Buncombe County Planning Board April 15, 2013

SUB2013-00077

Brush Creek Subdivision applied for preliminary approval to site a major subdivision on the Northern side of Brush Creek Road in between the intersections of Upper Brush Creek Road and Witch Hazel Way (PIN 9685.32.5838).

Buncombe County Planning Board Meeting Recommended Staff Conditions **SUB2013-00077** April 15, 2013

DRAWN BY: MAD

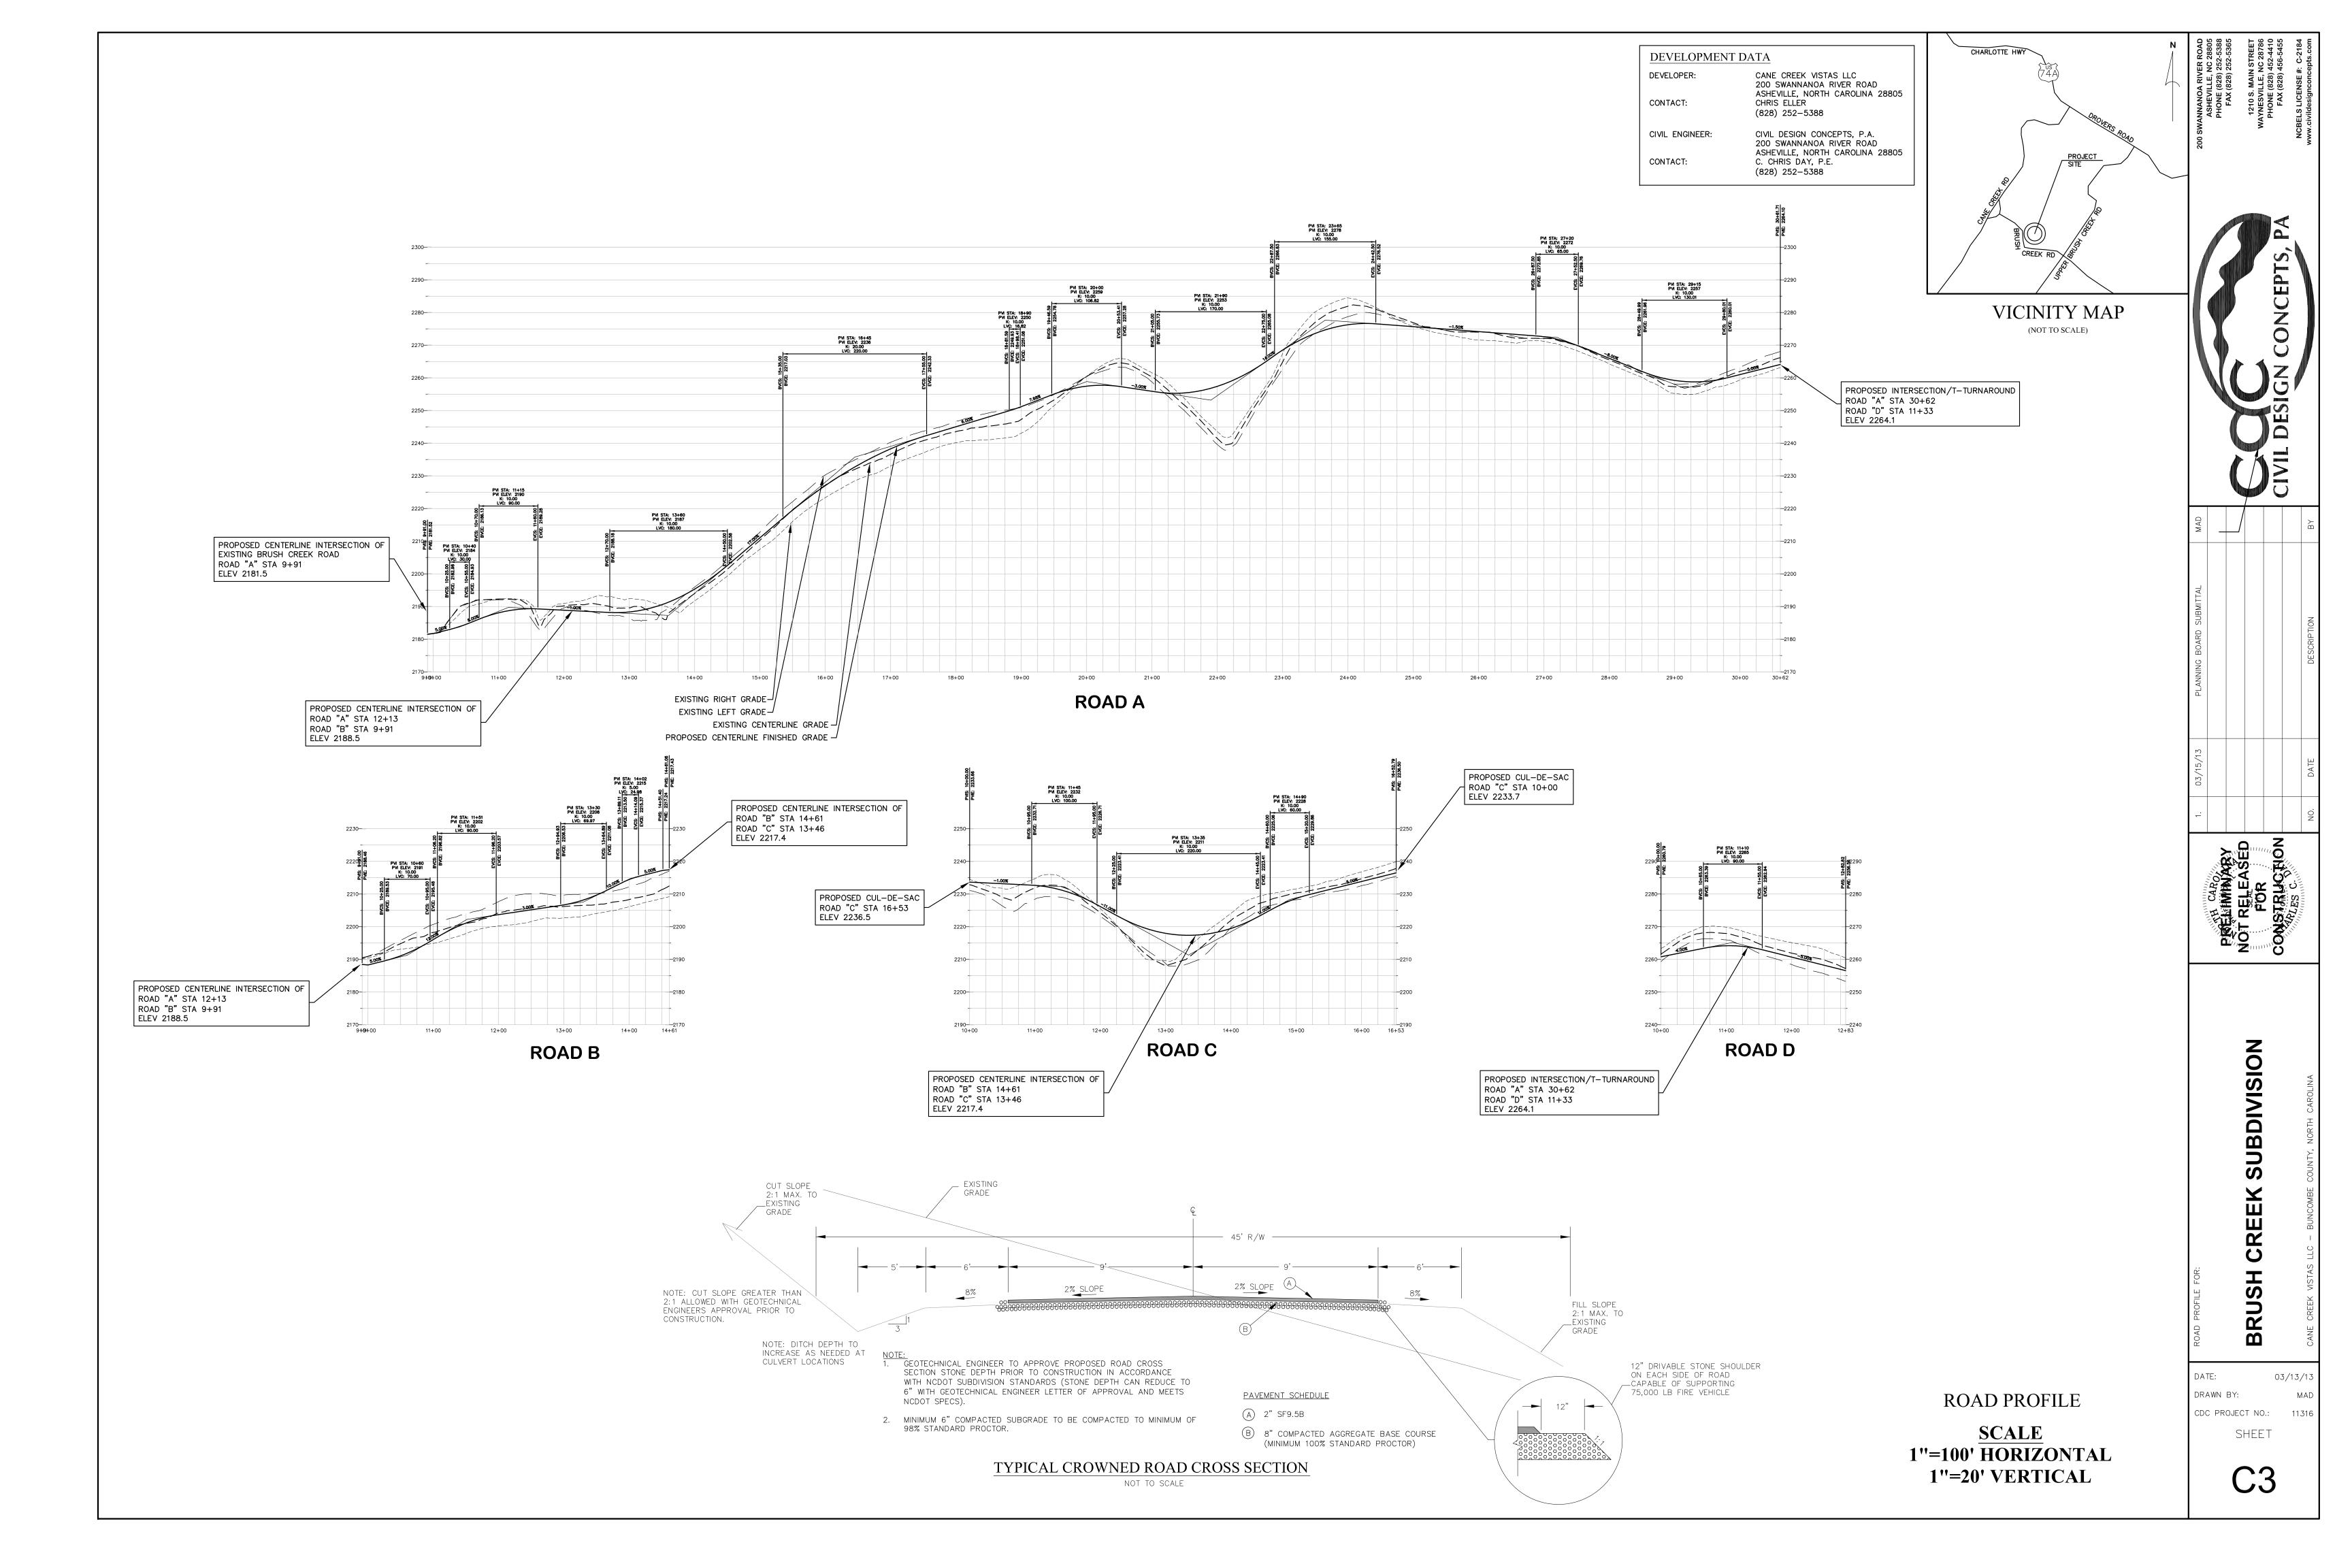
- 1. Indicate on the submitted plans that the lots will be served by septic and well.
- 2. Indicate the name of the owner on the submitted plans.
 3. Indicate the township the subdivision is located in on the submitted plans.

- 4. Indicate provision of the following on the submitted plans:
- a. Provisions for electrical and telephone services;
- b. Provisions for cable television service, if applicable;c. Provision of natural gas lines if applicable; and

- Or indicate that no provision for the items listed above has not been made.
- 5. Indicate contour interval on the submitted plans.
- 6. Indicate the existing use of the land within the subdivision.

- 7. Provide a copy of the approved North Carolina Department of Transportation driveway permit.
- 8. Provide proof of approval of road names and addresses from E-911 Addressing.

- 9. Provide curve data for proposed roads.
- 10. Indicate on the submitted plans that no base course shall be placed on muck, pipe clay, organic matter or other unsuitable matter, and a minimum compaction rate of subgrade prior to paving shall not be less than 95 percent by standard proctor method.

- 11. Provide information on the submitted plans that the subdivision roads meet the following standard: they are contained within a corridor that shall not exceed 90 feet in width along 80% of its total length; up to 20% of the length of the road corridor may be graded to a maximum width of 135 feet. The corridor height, defined as the height of a combined cut and fill slope, shall not exceed 60 feet.

- 12. Indicate areas of road construction in excess of 30 percent natural slope or areas designated as High Hazard or Moderate Hazard on the Buncombe County Slope Stability Index Map or indicate on the submitted plans that no such areas exist.

- 13. Indicate location of individual driveways for the first 20 feet for each lot on the submitted plans.
- 14. Subdivision roads shall be paved in accordance with NCDOT "Subdivision Road Minimum Construction Standards," Pavement Design 1(E), current edition. Specify soil conditions and which combination of base and pavement design (see DOT guidance) will be used. Use worst-case design criteria if soil testing is not

- 15. Proof of preliminary soils investigation that will evaluate the feasibility of developing a subdivision served by individual septic systems, which shall be done by a professional such as a soils engineer or soils scientist

- 16. Provide a written statement from the Buncombe County Erosion Control Officer stating that an Erosion Control Plan has been submitted and approved for the project. No grading shall occur on the site until an approved Buncombe County Erosion Control permit is obtained.

- 17. Provide a written statement from the Buncombe County Stormwater Administrator stating that a stormwater management plan has been submitted and approved for the project. No grading shall occur on the site until an approved Buncombe County Stormwater Permit is obtained.
